Errata for the
PCI Express[®] Base Specification
Revision 2.1

November 18, 2010

Revision	Revision History	Date
	Initial release.	06/08/2010
	Added errata A14-A21, B40-B91, and C1-C2.	11/18/2010

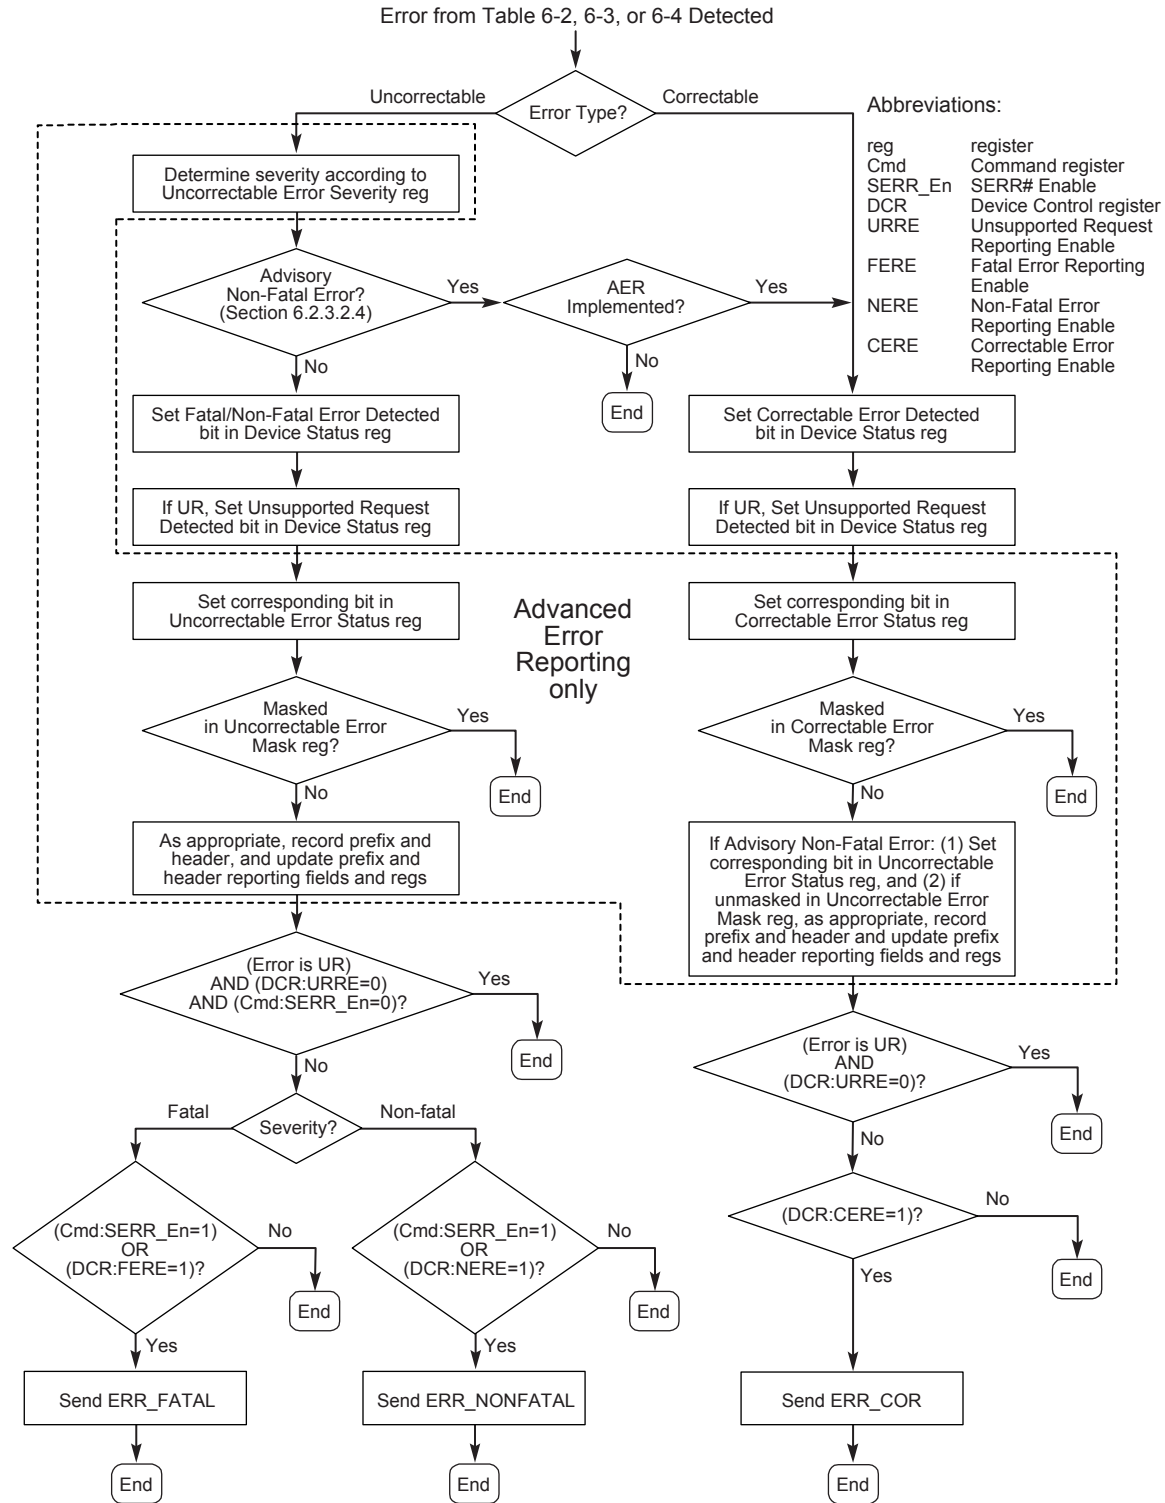
A 32-bit ECRC is calculated for the ~~entire~~ TLP (End-End TLP Prefixes, header, and data payload) using the following algorithm and appended to the end of the TLP (see Figure 2-3):

- The ECRC value is calculated using the following algorithm (see Figure 2-37).
- The polynomial used has coefficients expressed as 04C1 1DB7h
- The seed value (initial value for ECRC storage registers) is FFFF FFFFh
- All invariant fields of the TLP's End-End TLP Prefixes (if present), header, and the entire data payload (if present) are included in the ECRC calculation, all bits in variant fields must be set to 1b for ECRC calculations.

OM14544C

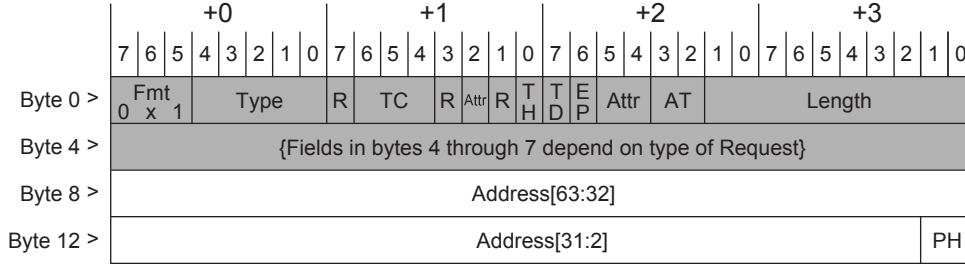
In Section 2.2.4.1, page 64, replace Figure 2-7: 64-bit Address Routing with the following:

OM14543C

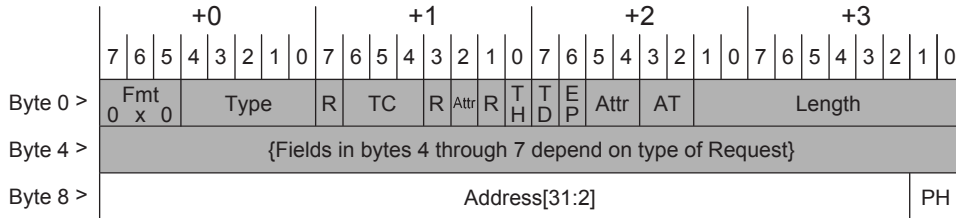
In Section 2.2.4.1, page 64, replace Figure 2-8: 32-bit Address Routing with the following:

OM13764C

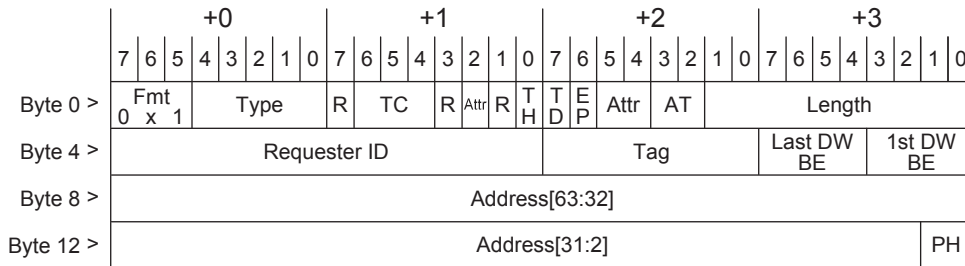
In Section 2.2.7, page 77, replace Figure 2-15: Request Header Format for 64-bit Addressing of Memory with the following:

OM13763C

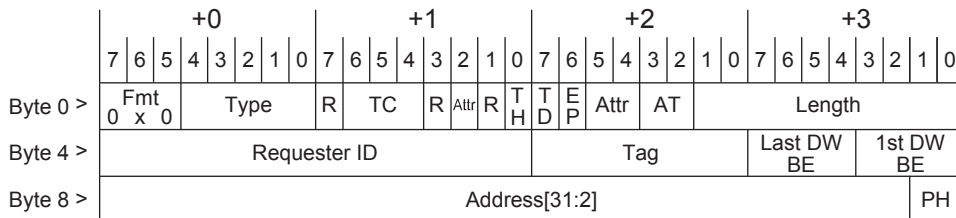
In Section 2.2.7, page 77, replace Figure 2-16: Request Header Format for 32-bit Addressing of Memory with the following:

Figure 4 22: Transmitter Margining Voltage Levels and Codes

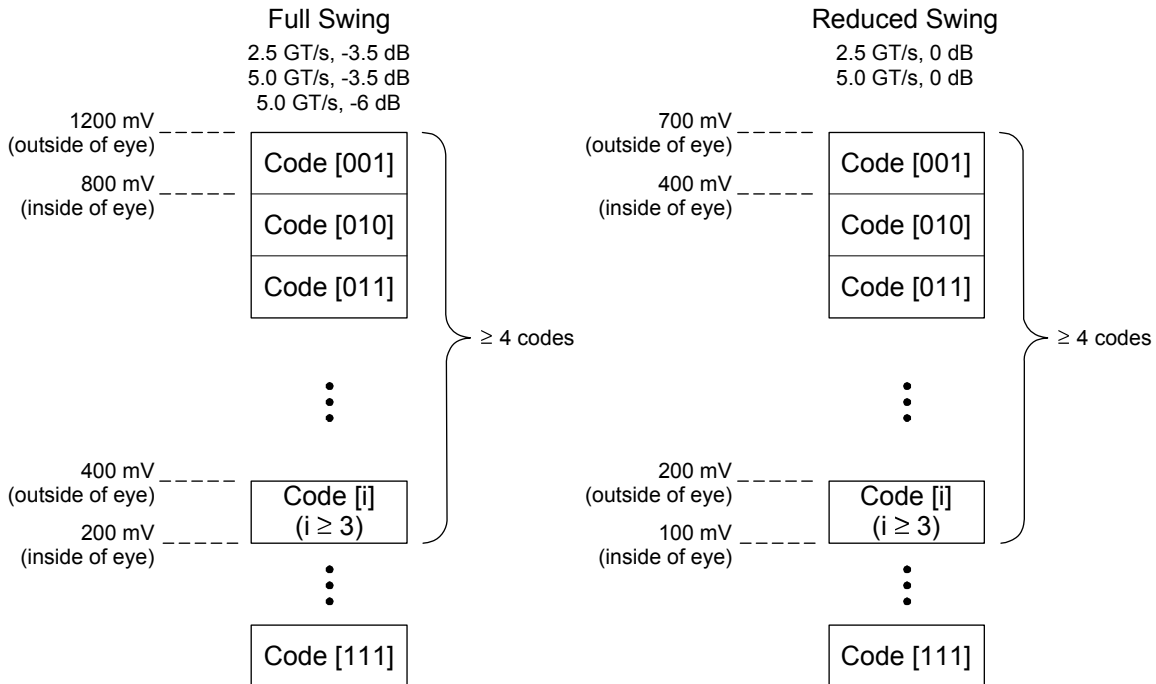
In Section 4.3.3.3, page 267, replace Figure 4-22 with the following:

Figure C-1: Scrambling Spectrum at 2.5 GT/s for Data Value of 0

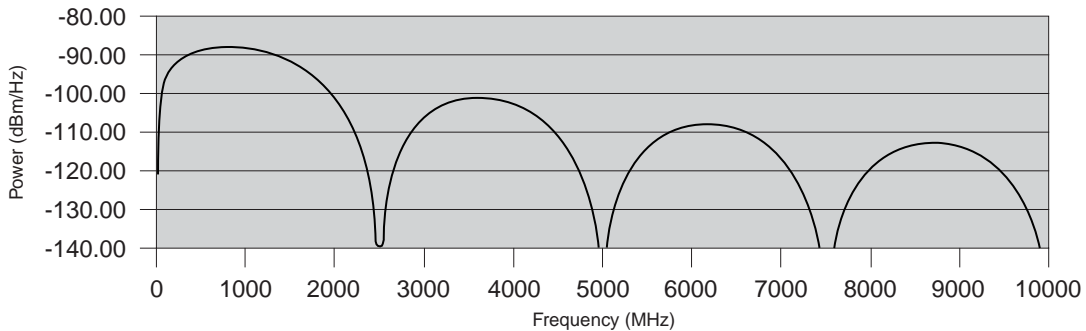
In Section C1, page 685, make the following edits on line 1:

At 2.5 GT/s, scrambling produces the power spectrum (in the 10-bit domain) shown in Figure C-1.
